**Floppy-disk interface for the Junior**

(December 1982, page 12-48)

**Single-channel infra-red remote control**

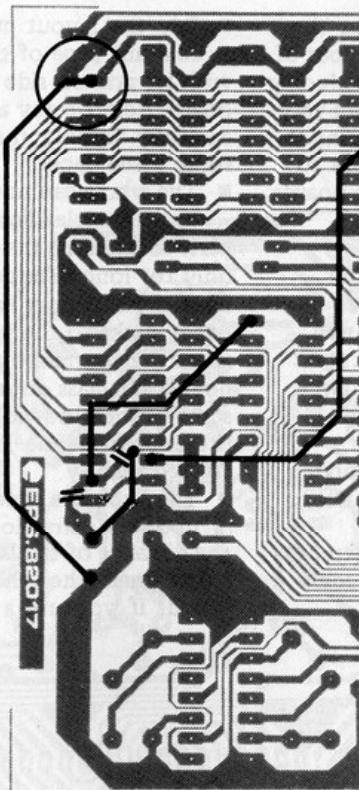
In figure 2 on page 1-52, FF1 is shown as a flip-flop, whereas it should be a monostable. This can be corrected by connecting pin 11 of IC2 to ground.
